CITY OF LAKEWOOD
LAKEWOOD TOWN SQUARE
CIP PROJ. NO. P2CC2623; BID NO. PW24-07

ADDENDUM NO.1

ADDENDUM NO. 1

PROJECT TITLE: LAKEWOOD TOWN SQUARE

SHEET
C3.00

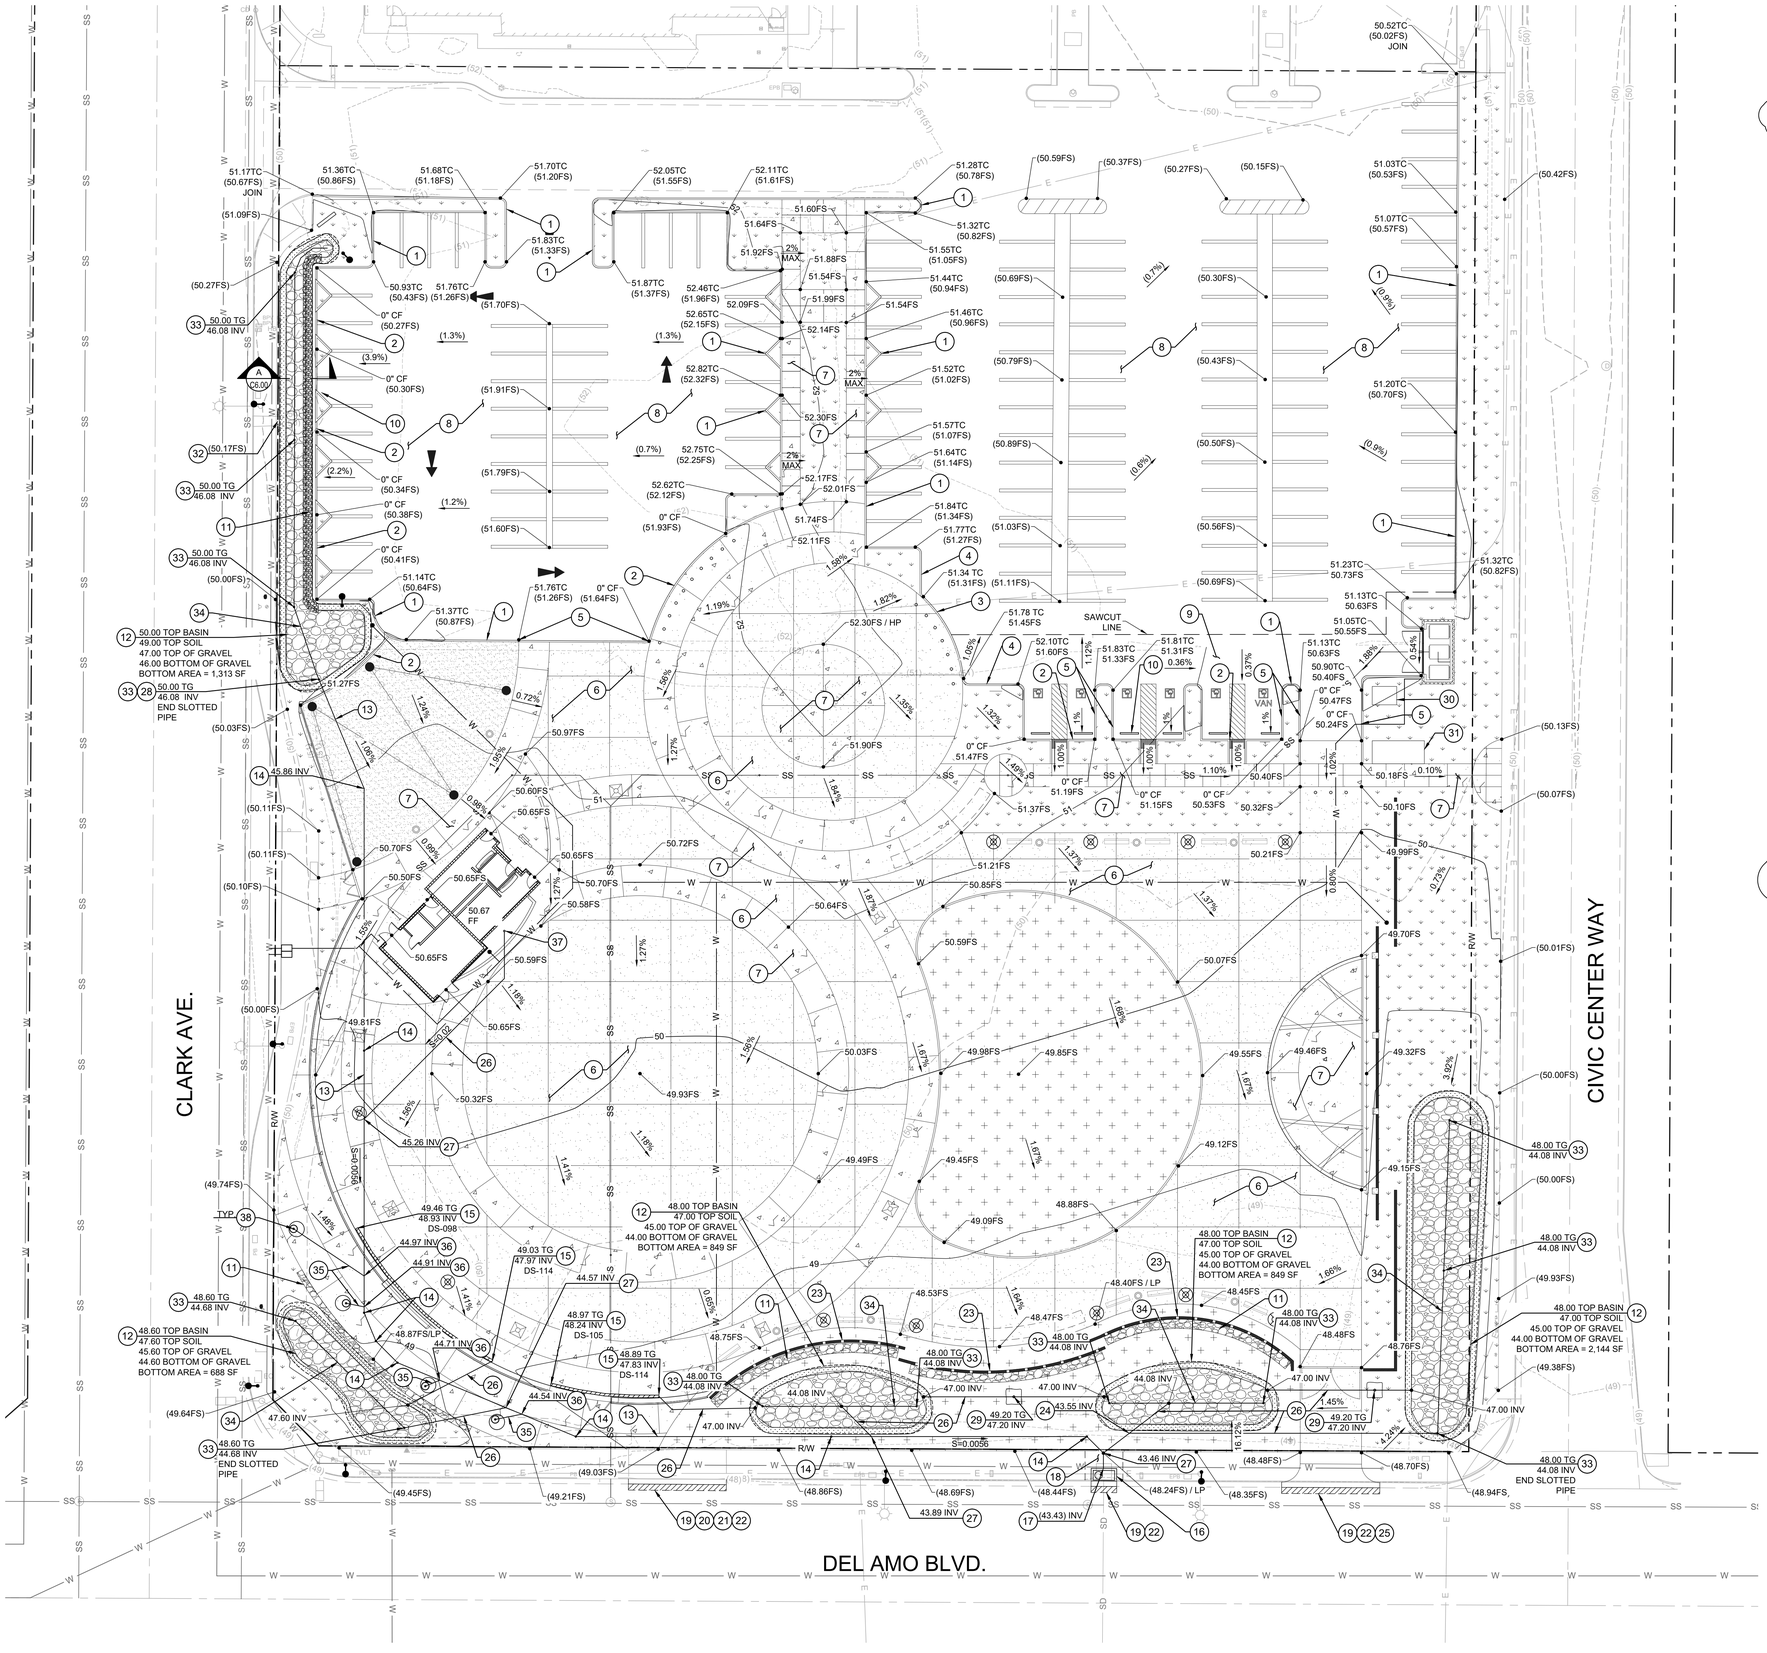
A18	**Please see Addendum 1 for revision to C5.00. Rolled curb has been revised to flarted curb and transition has been revised to show gutter transition**
Q19	Walkway Joints: Please confirm whether the ⅝" fiberglass-reinforced polymer dowels and Speed Dowel sleeves specified in Sections 321313.1 and 321316 are required at pedestrian walkway joints. Landscape Detail 11 shows expansion and control joints without dowels. Please clarify if dowels are required where concrete meets concrete.
A19	**Yes, confirmed on use of polymer dowels and dowel sleeves as specified. Yes on dowels being required where concrete meets concrete.**
Q20	Per Irrigation legend, the number of root watering system is indicated for 24" box, 36" box and 48" box. However, there is no information for 72" box as per Planting legend. Please clarify.

4. CONSTRUCT P.C.C. FLARED CURB TRANSITION PER DETAIL ON SHEET C5.00. △1
5. CONSTRUCT 6" TO 0" P.C.C. CURB TRANSITION PER DETAIL ON SHEET C5.00.
6. CONSTRUCT CONCRETE PAVERS PER LANDSCAPE PLANS, PLACED OVER 4" A.B. AND COMPACTED SUBGRADE PER CIVIL DETAIL 7 ON SHEET C5.00. (ALTERNATE #1 OPTION: PCC CONCRETE IN PLACE OF PAVERS PER NOTE #7)

SHEET
C4.00

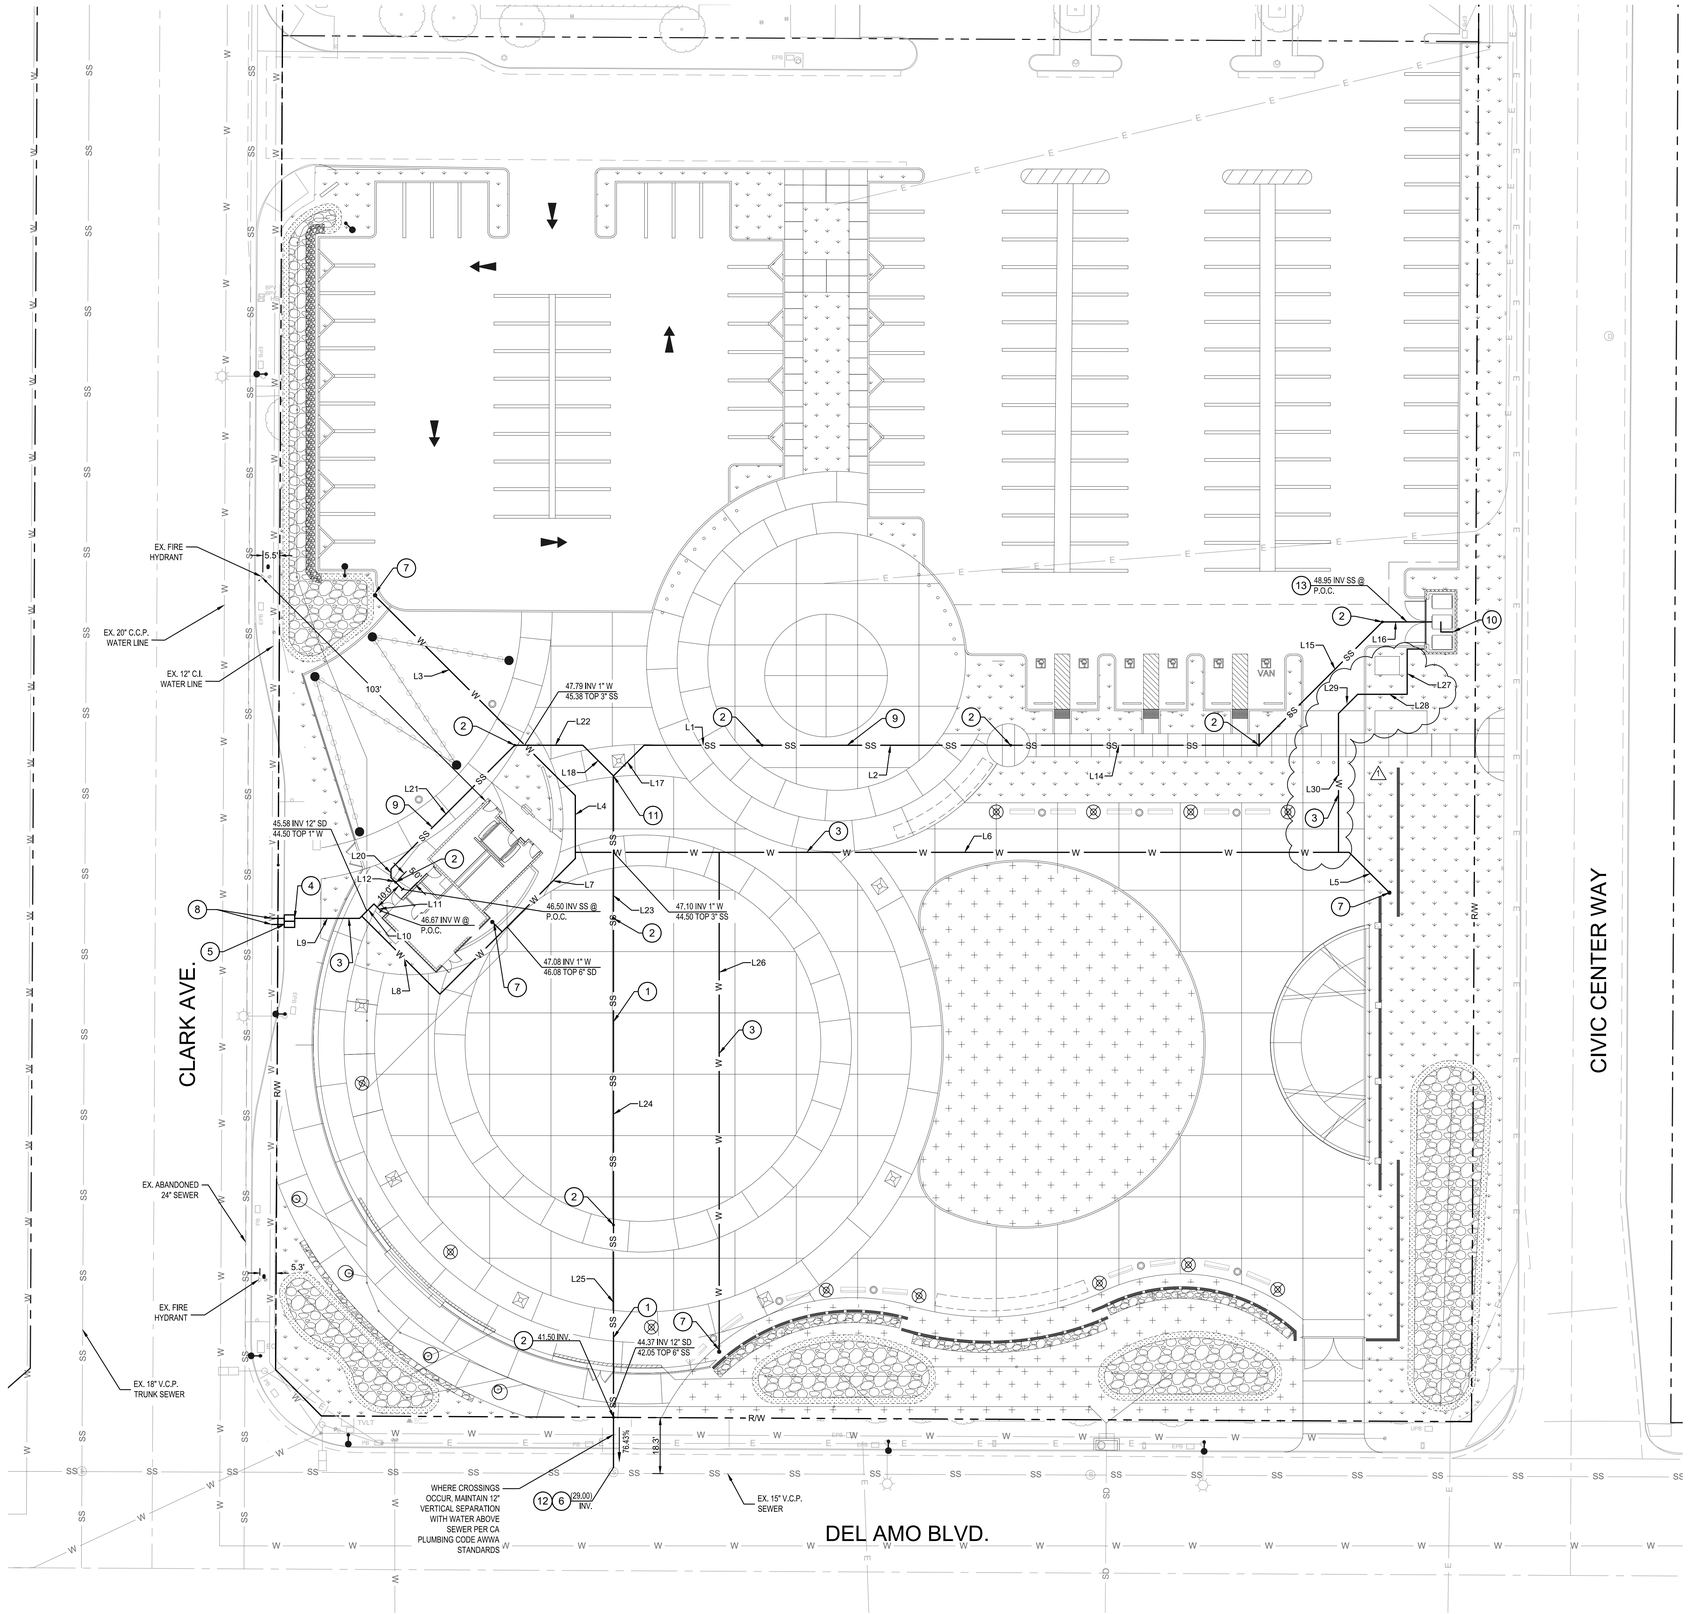
A6	**Please see Addendum 1 for revision to C3.00. 2" pipe has been revised to 4"**
Q7	Keynote 09.06 is missing a description in the keynote legend on Sheet A511. Please clarify the scope of work associated with this keynote.
A7	**Please see Addendum 1 for revision to A511.**

SHEET
A101

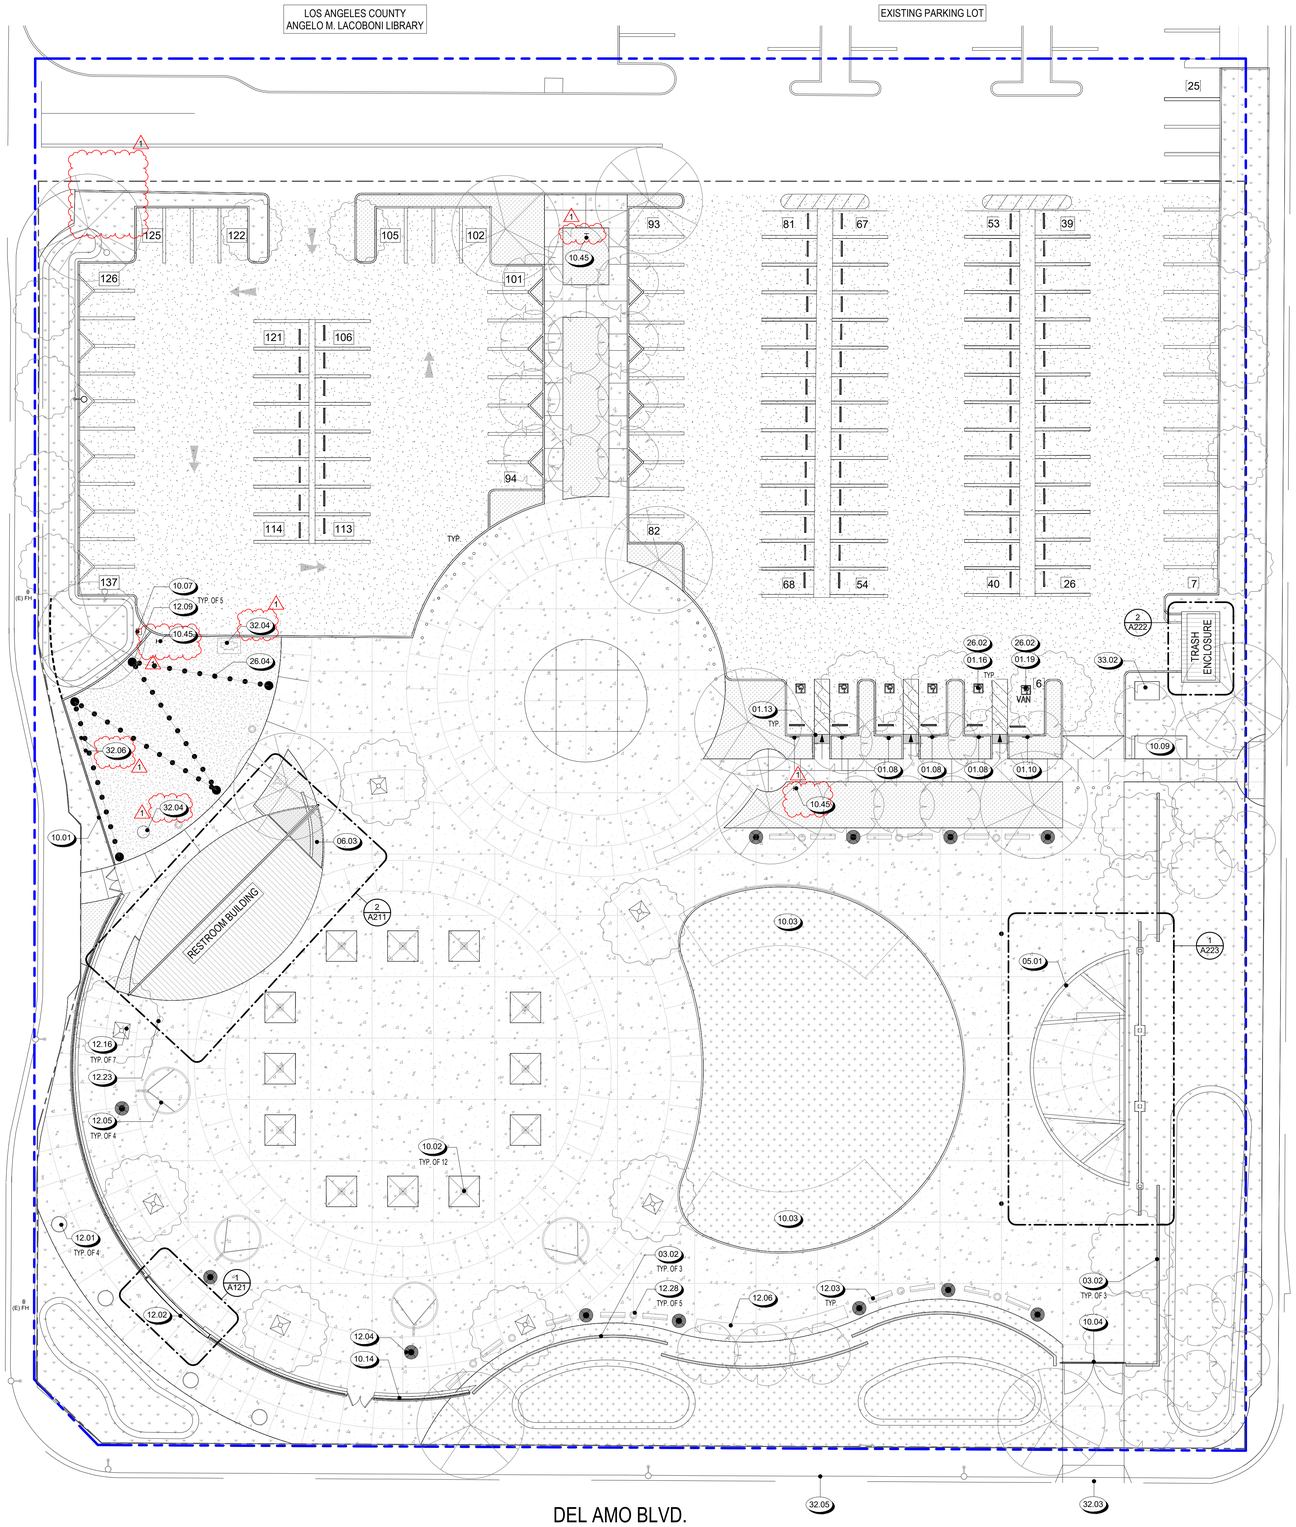
A3	**Please see Addendum 1 for revision to A211. 10.43 has been changed to 10.45 and has been moved to A101.**
Q4	Keynote 10.44 is missing a description in the keynote legend on Sheet A211and A512. Please clarify the scope of work associated with this keynote
A4	**Please see Addendum 1 for revision to A211 and A512. 10.44 has been changed to 10.46.**
Q5	Keynote 10.42 is missing a description in the keynote legend on Sheet A511. Please clarify the scope of work associated with this keynote.
A5	**Please see Addendum 1 for revision to A512.**
Q6	Grading Construction Note 35 on Sheet C3.00 calls for 2" SDR-35 PVC storm drain pipe at the planter drain connections to the 12" SDR-35 storm drain main. SDR-35 PVC per ASTM D3034 is manufactured in 4" through 15" only. 2" SDR-35 is not available. Note 36 calls for 12" x 2" x 12" PVC tee which is also not a standard fitting. Please confirm the following: 1. Size and material for note 35: 2" Schedule 40 PVC, 4" SDR-35 or otherwise 2. Acceptable connection of the lateral to the 12" SDR-35 main in place of the Note 36 tee.

10.45	POLE MOUNTED PARK SIGNAGE, OWNER TO PROVIDE FINAL GRAPHIC AND LOCATION, SEE DETAIL 21/A901.
12.01	CONCRETE PLANTERS, S.L.D.
12.02	DIGITAL MONUMENT SIGN, PROVIDE POWER AND DATA CONNECTIONS. SEE SHEET A121 & S.E.D.

SHEET
A211

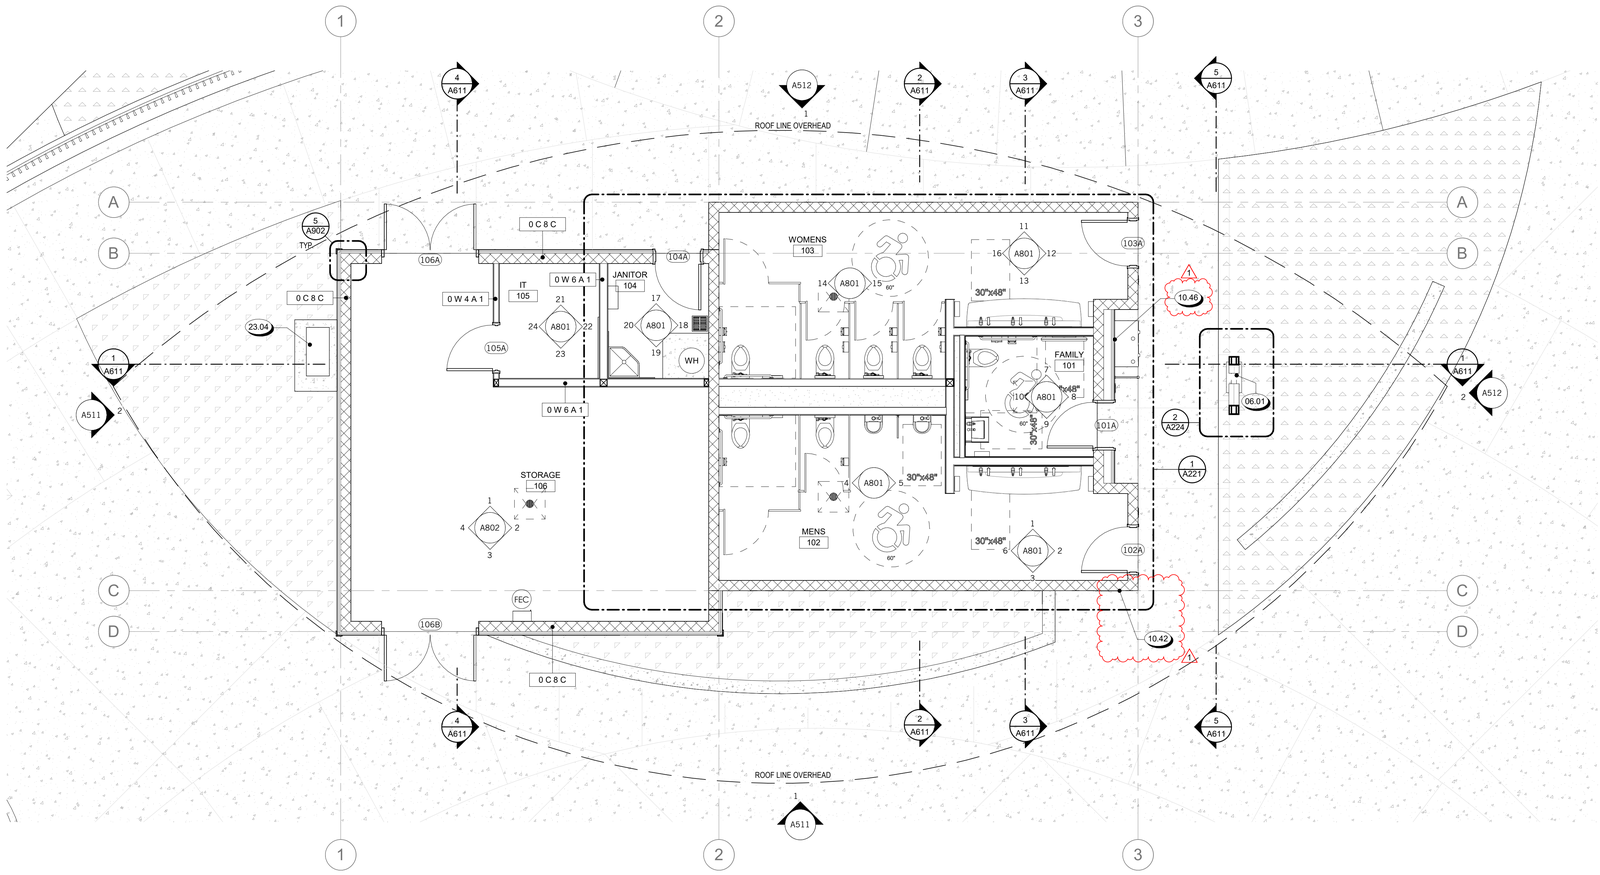
A13	**Please see Addendum 1 for revision to A211 and A511.**
Q14	Please confirm whether the City will accept a single umbrella/excess liability policy covering General Liability, Automobile Liability, and Employer's Liability to satisfy the required
